I am submitting this letter to formally request a Critical Area Variance for Property at 348 Hunner Road, Pasadena, Maryland. This request concerns the in-kind replacement of an existing two-story deck. The lot is situated about 60 to 70 feet from the shoreline, within the 100-foot Critical Area Buffer but outside the most environmentally sensitive zones. Strict enforcement of the Critical Area regulations would impose an undue hardship, as it would prohibit the replacement of the existing structure, which has become structurally unsafe.

**LOCATION DRAWING OF:
 #348 HUNNER ROAD
 LOT B**

PROJECT NOTIFICATION APPLICATION

REMOVE AND RE-BUILD TWO STORY WOOD DECK ON REAR, NEW DECK TO BE THE EXACT SAME SIZE AND ON THE SAME LOCATION

DECK PLANS

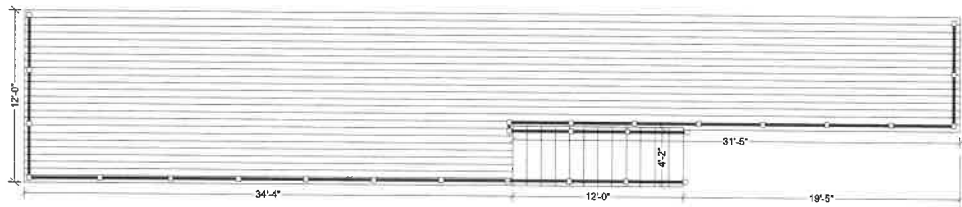
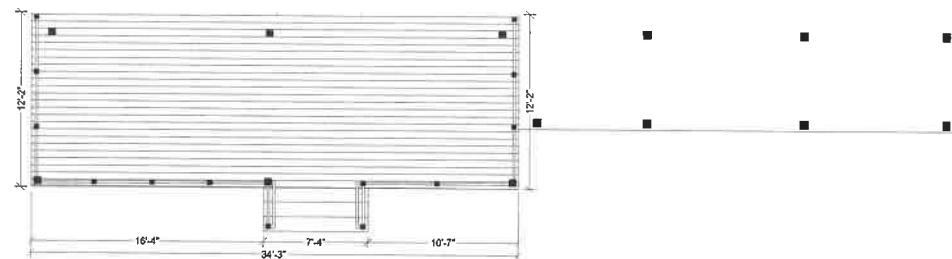
The **Zoning Administration Section** notes that the current proposal appears to exceed the area of the existing deck being removed. In order to allow for proper review, the applicant should submit an existing conditions site plan and a proposed conditions site plan, and both levels of deck should be shown on the site plan with dimensions for each level. The site plan should also be updated to show the slopes of 15% or greater, the buffer, and the limit of disturbance (LOD) required for access during construction. The property already has the luxury of extensive decking that far exceeds that which is typical of most waterfront lots in sloped areas. Any expansion of the existing deck would not be supported. In fact, redevelopment allows the opportunity for minimization and to improve upon the existing conditions. The applicant is advised that, in order for the proposed Critical Area variances to be approved, the applicant must demonstrate and the Hearing Officer must find that the proposal complies with each and every one of the Critical Area variance standards provided under Section 18-16-305(b) and (c), including demonstrating that the variances are the minimum necessary to afford relief. Therefore, the variance letter of explanation should be revised to specifically address each standard.
